INNER WEST COUNCIL

DEVELOPMENT ASSESSMENT REPORT

Application No.	D/2018/541
Address	50-58 Evans Street, Rozelle
Proposal	Alterations and additions to existing hardware store building to facilitate its conversion into 3 x 2 storey dwellings with associated parking, and associated works, including excavation to include a basement and remediation of the site.
Date of Lodgement	17-Oct-2018
Applicant	Matco Holdings Pty Ltd
Owner	Matco Holdings Pty Ltd
Number of Submissions	Objections from 13 properties
Value of works	\$1,900,000
Reason for determination at Planning Panel	<ul style="list-style-type: none"> Number of objections exceeds officer delegation Clause 4.6 variation to Site Coverage exceeds 10%
Main Issues	Impact to Heritage Conservation Area, Issues in relation to Car parking, Visual Privacy
Recommendation	Approved with Conditions
Attachment A	Recommended conditions of consent
Attachment B	Plans of proposed development
Attachment C	Clause 4.6 Exception to Development Standards

DRAWING NO: **DA19**

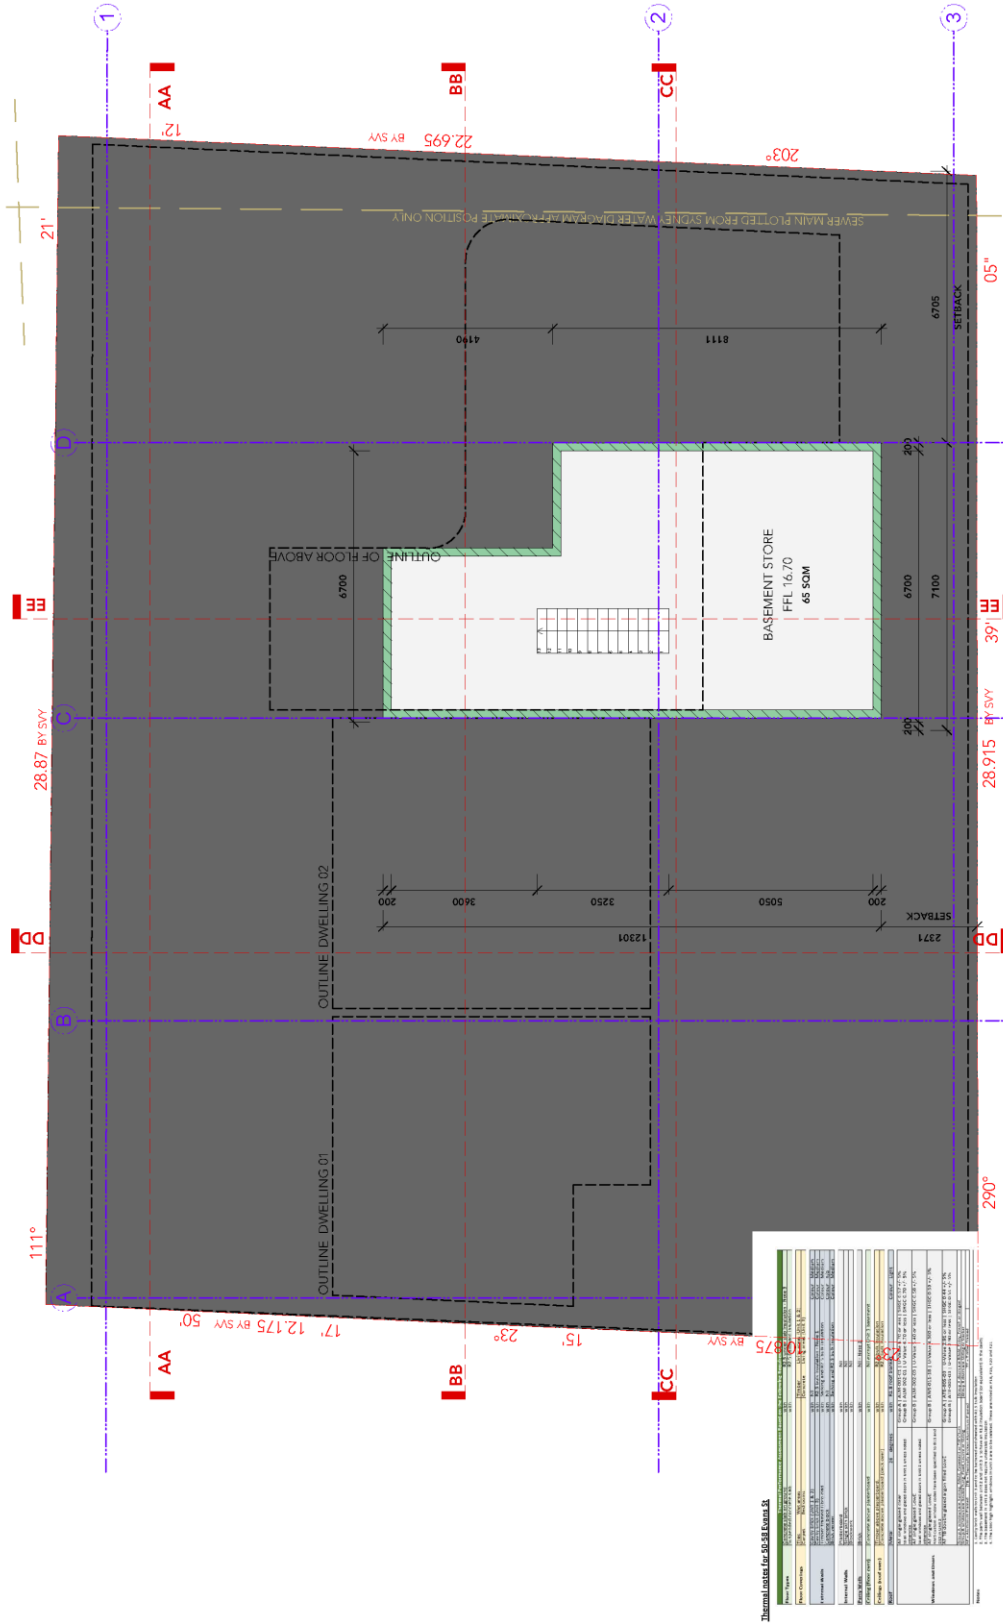
The materials and finishes board still indicates it is proposed to paint the facades. The applicant is encouraged to engage qualified tradespeople to remove the paint using a proprietary paint cleaning product suitable for heritage structure buildings. No high pressure water or sandblasting is to be used for the removal of paint. Alternatively, if it is preferred to paint the building, only surfaces that have been previously painted are to be repainted. Face brickwork is to remain unpainted. In addition, a pre-coloured traditional corrugated steel shall be used for the roofing, finished in a colour equivalent to Colorbond colours "Windspray" or "Wallaby".

PREPARED FOR MATCO HOLDINGS PTY. LTD.
 DRAWING NO. **DA03**
 REVISION A

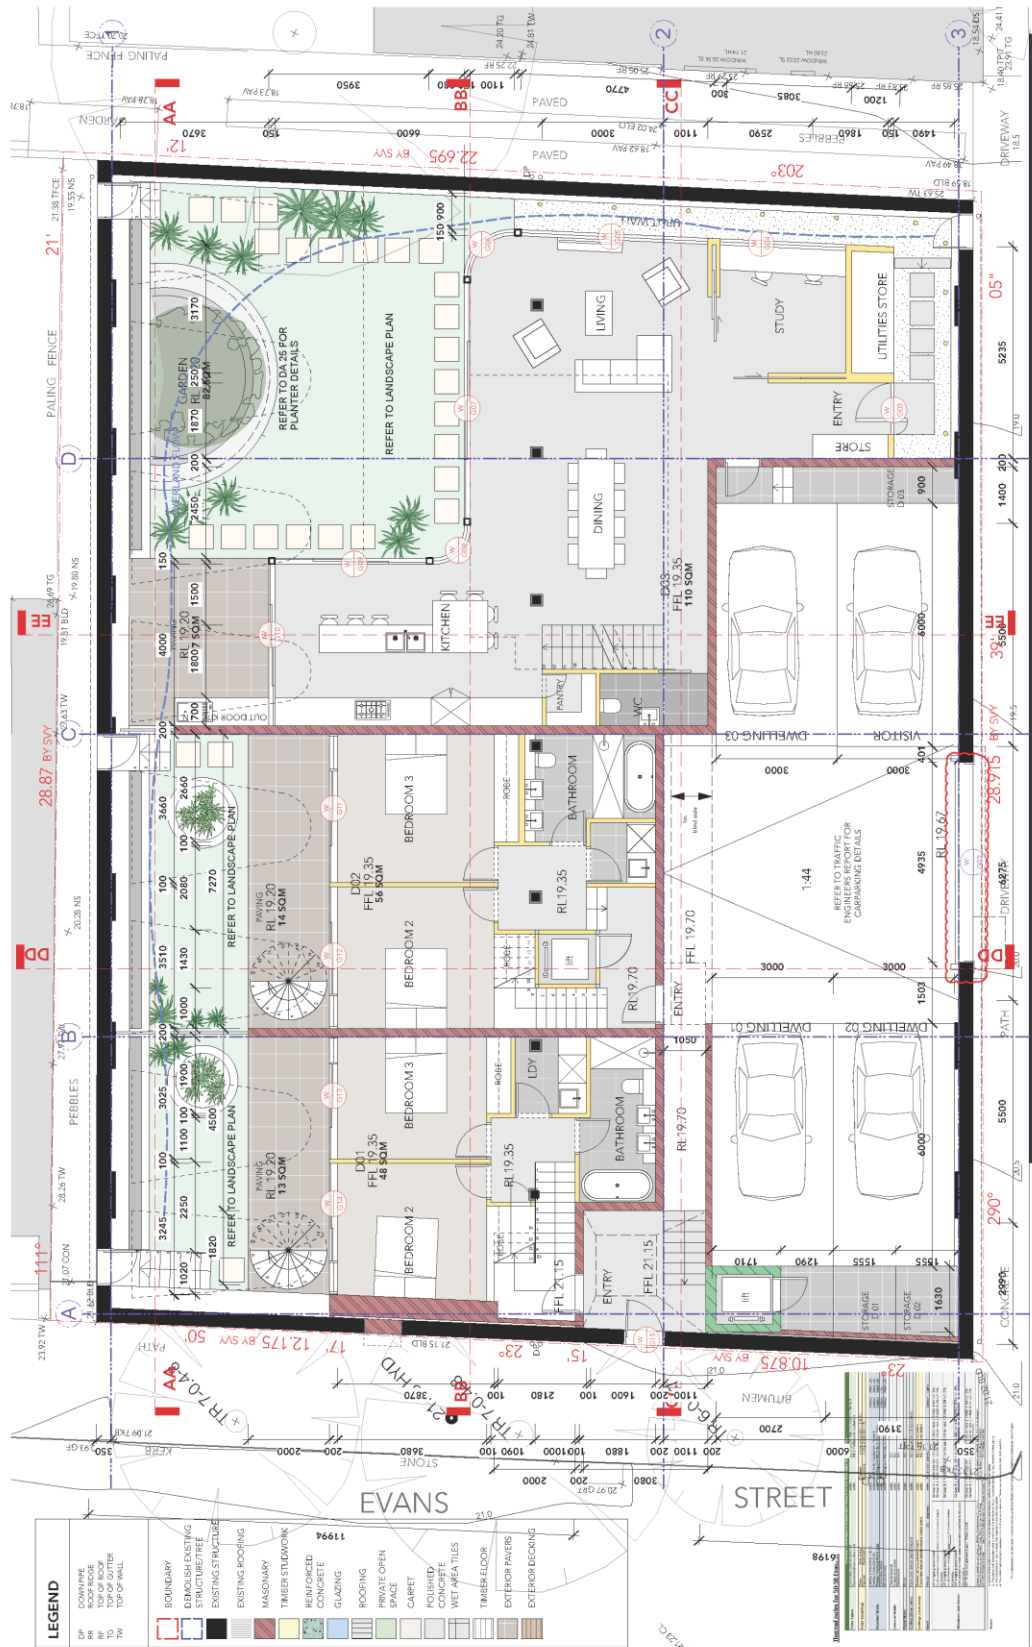
Also, to ensure the safety of pedestrians entering the middle dwelling will not be impacted by the manoeuvring of cars in the parking space, a condition will be recommended to locate the entry to the middle dwelling 1 metre further to the west so that the entry is located within the pedestrian corridor rather than within the parking area. This will require the internal areas of Dwelling 1 (the most west dwelling) to be reconfigured to accommodate this change.
